**ANN ARBOR HISTORIC DISTRICT COMMISSION**

**Staff Report**

**ADDRESS:** 1137 Traver Road, Application Number HDC19-236

**APPLICATION:** The applicant seeks HDC approval to selectively demolish and replace portions of the north, south, and east walls of the 2-story section of the house; reconstruct the north porch; and remove the non-historic stucco.

**2** PORCH COLUMN BASE  
1 1/2" = 1'-0"

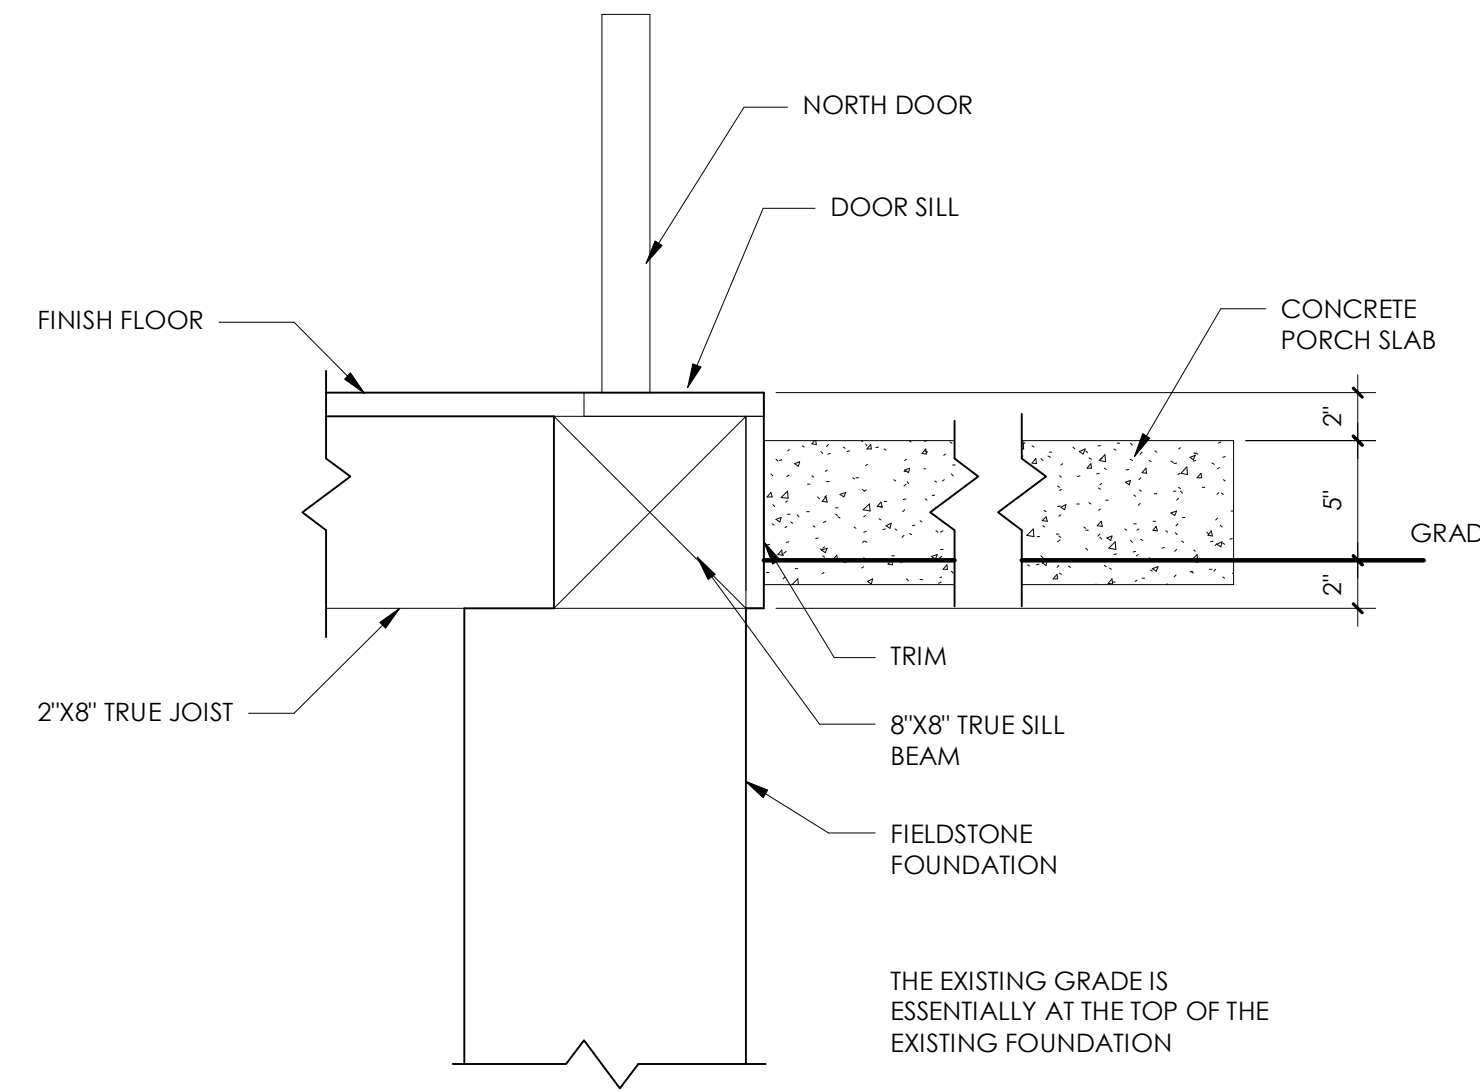
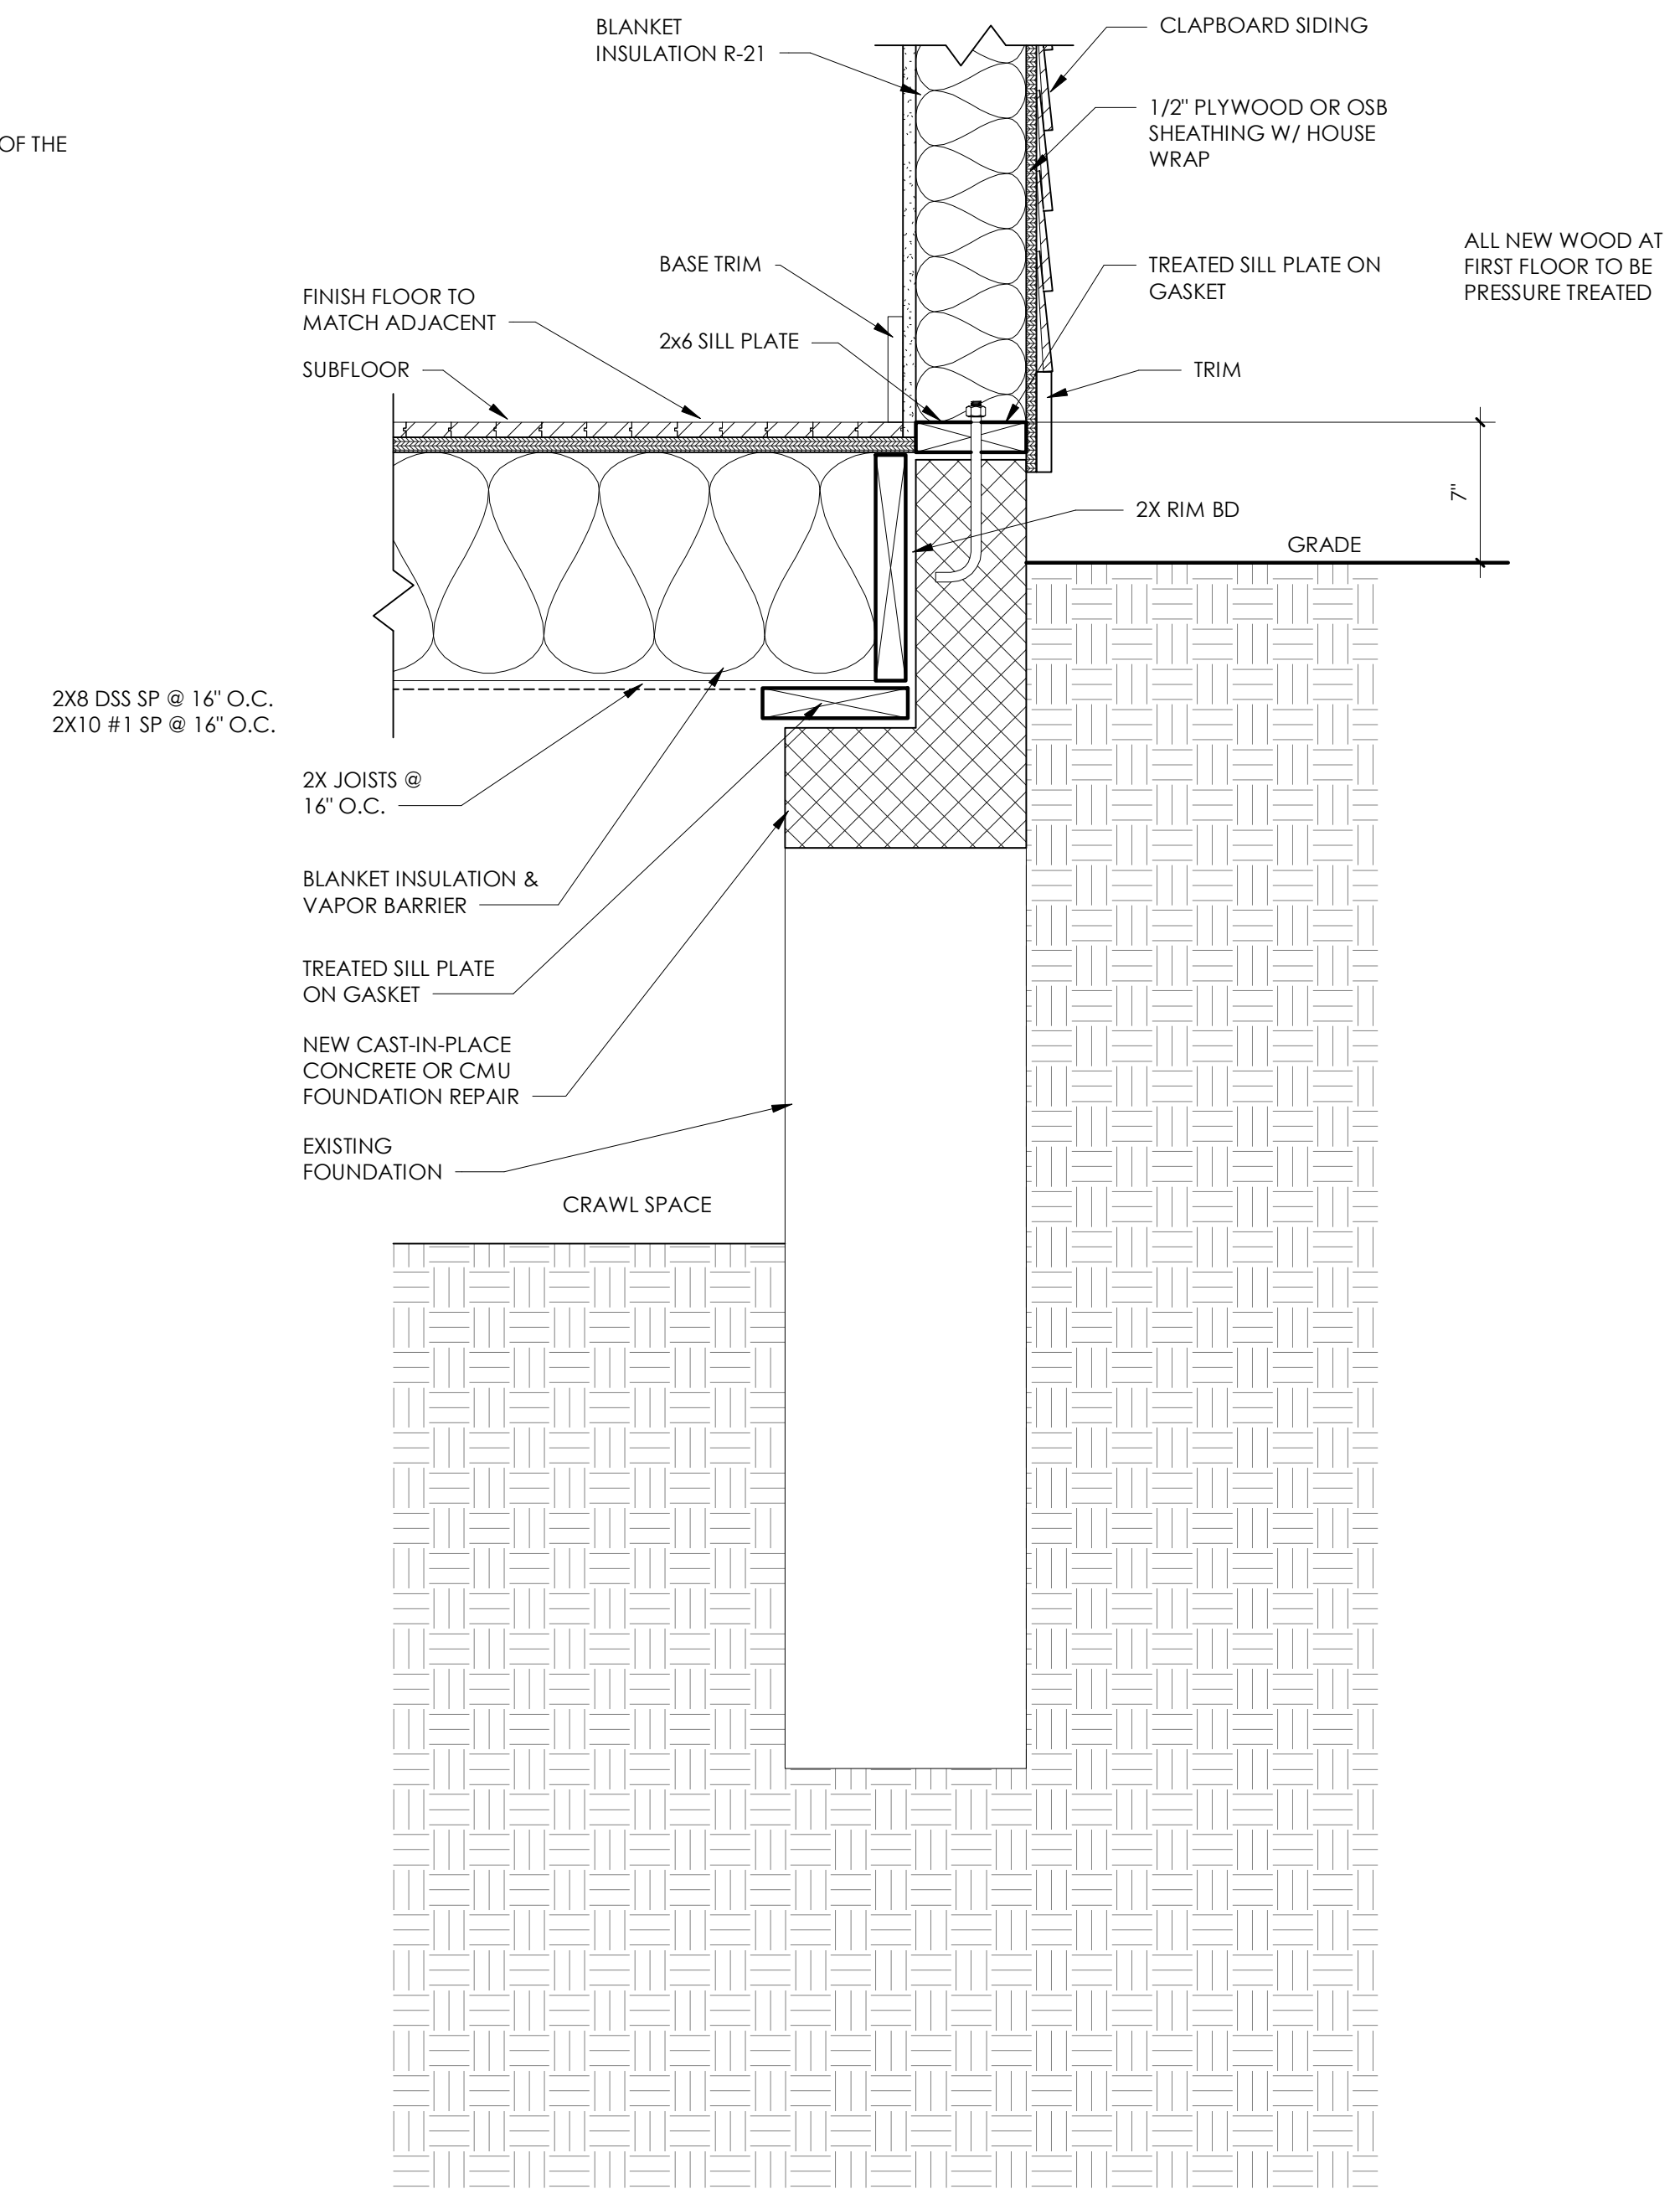
3. *Front Porch.* The proposal replaces the front porch with identified historic elements replicated (roof framing, trim, and brackets). The stucco porch wall would be removed. One addition is the porch column base shown on sheet G-001. The appearance of the original column bases is unknown, and this simple work is appropriate to the porch without being unduly ornate.

PROJECT NUMBER: 19.41  
DRAWN BY: BLR  
ARCHITECT: BLR  
SHEET NUMBER: A-100

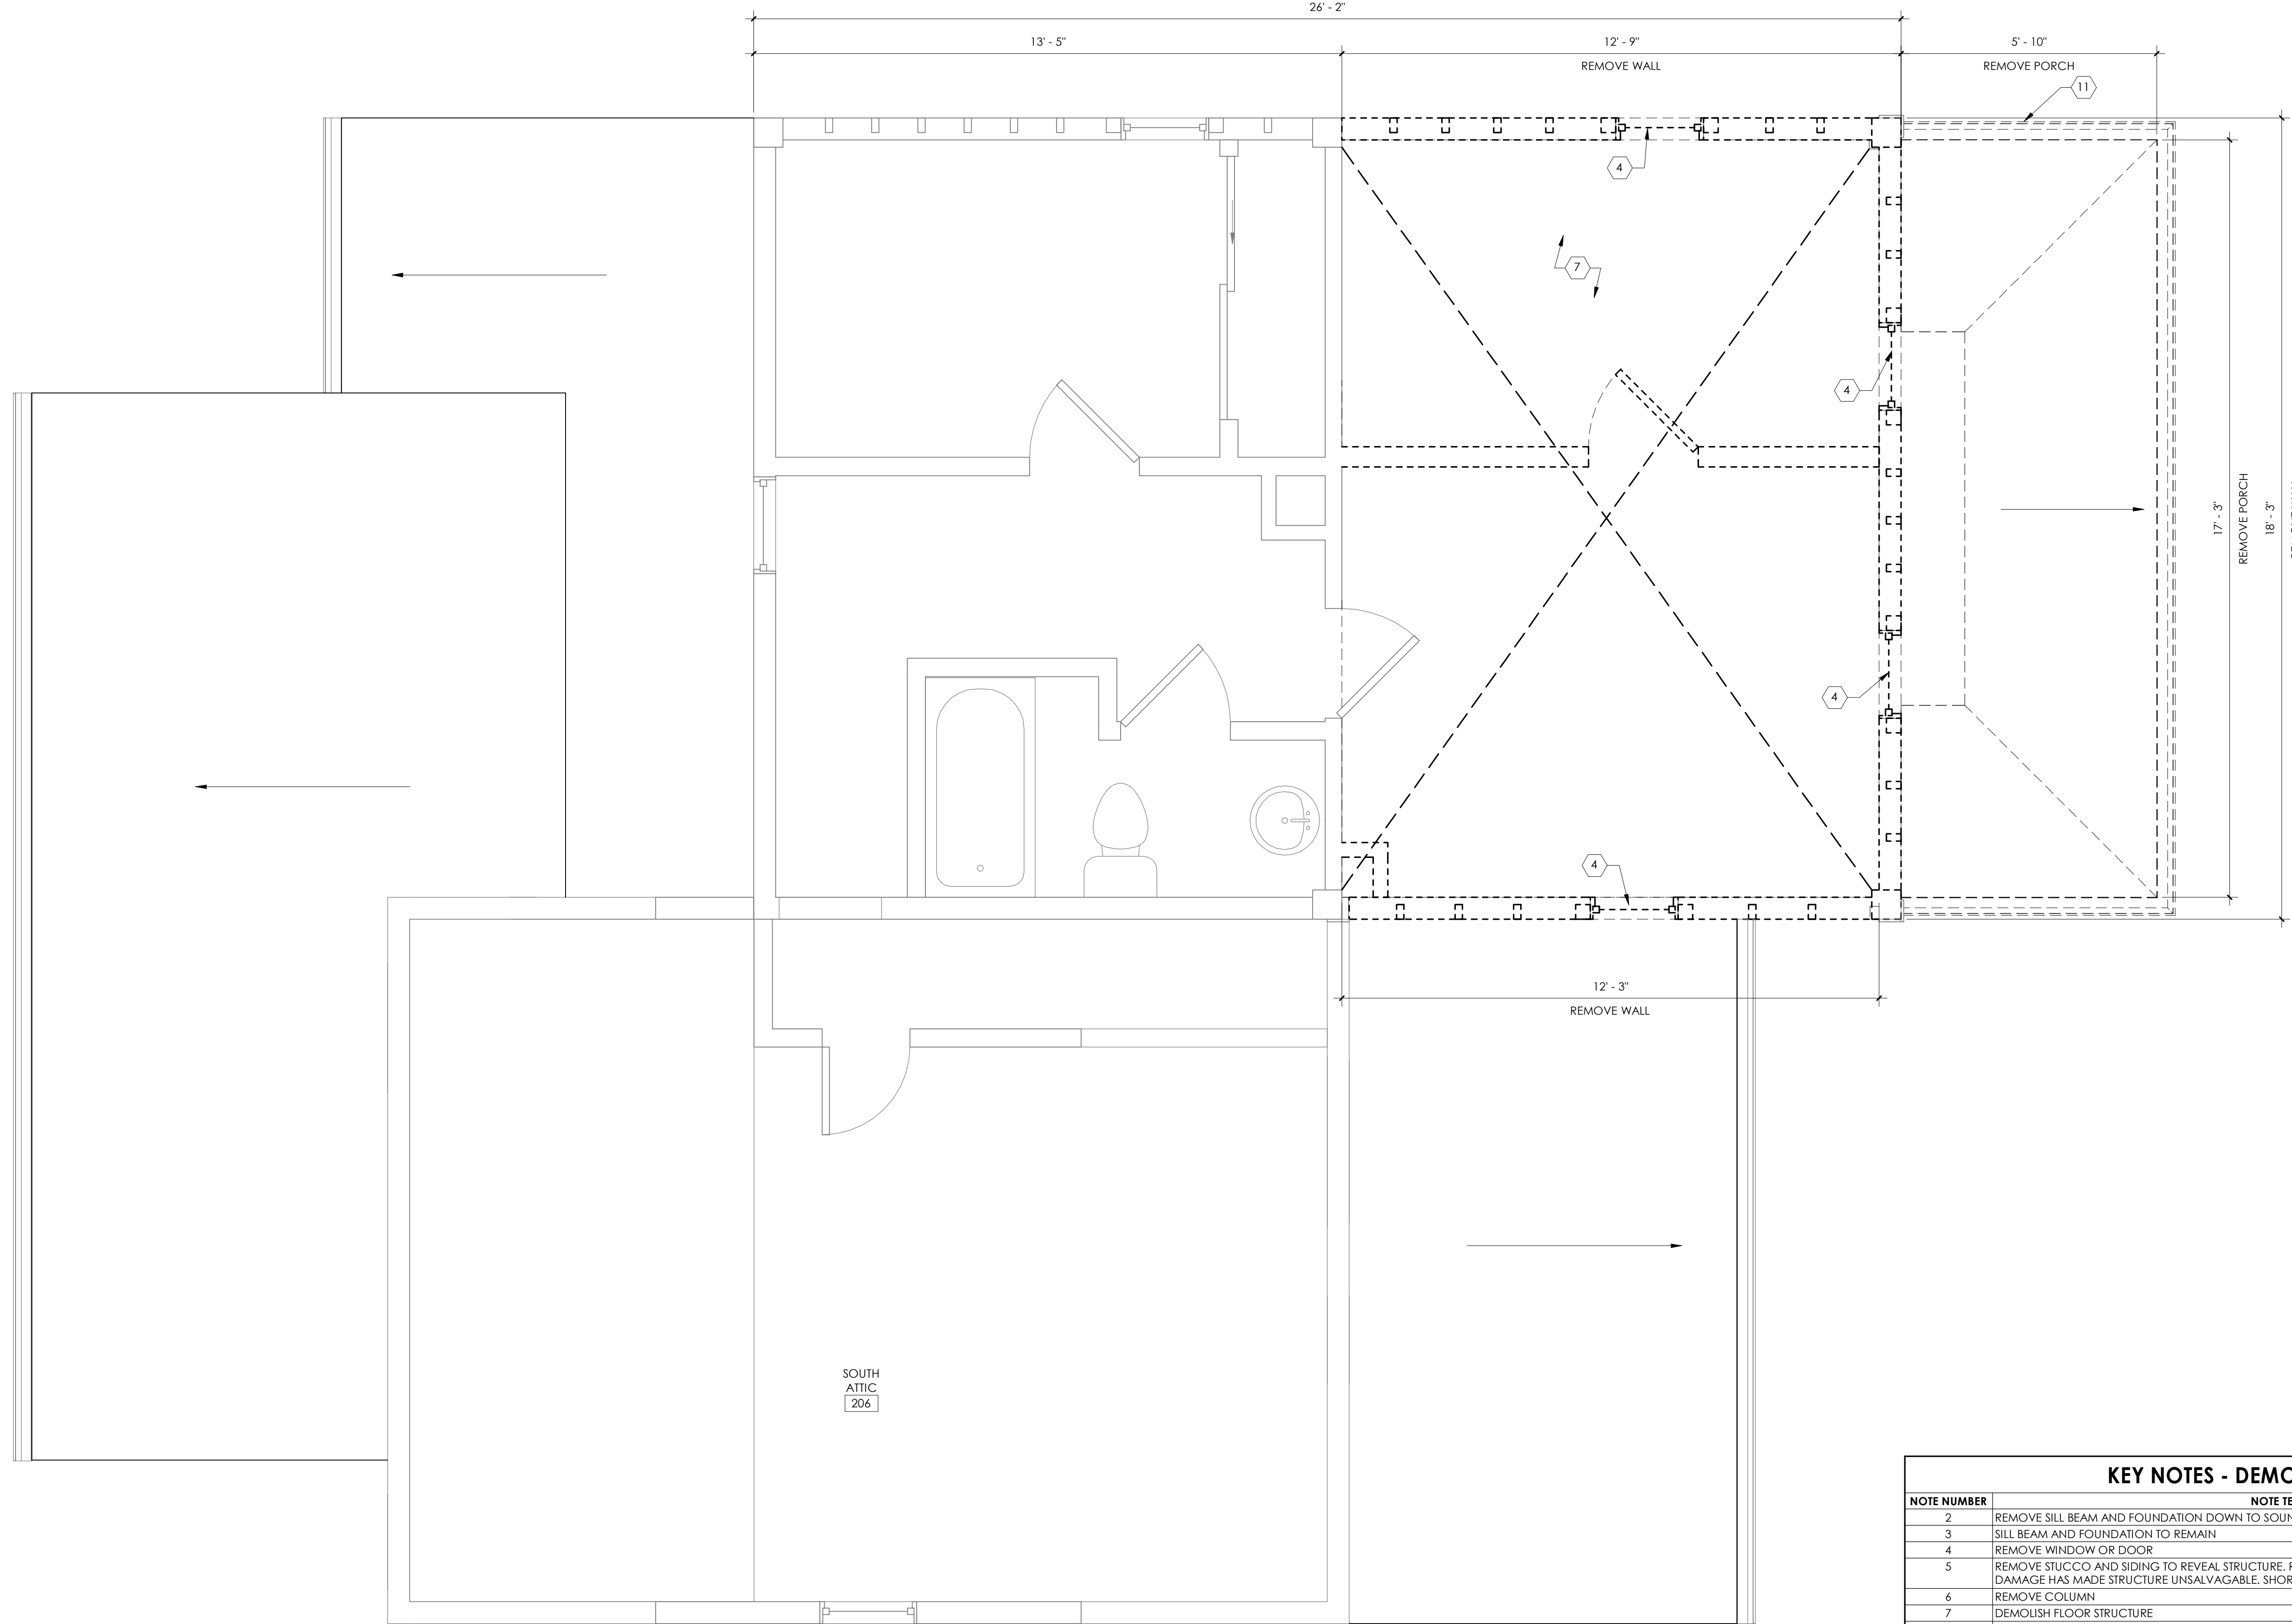
5. *Foundation.* The existing crawlspace wall under the portion to be reconstructed is rubble and stone but is not visible above grade. Only a few inches are exposed between the dirt and siding. Sheet A-100 specifies “repair top of foundation” but does not specify how. In a previous conversation with staff, the architect mentioned replacing it with concrete. Because nothing will be visually lost by repairing the foundation with poured concrete, staff has no objections, if that is the plan.
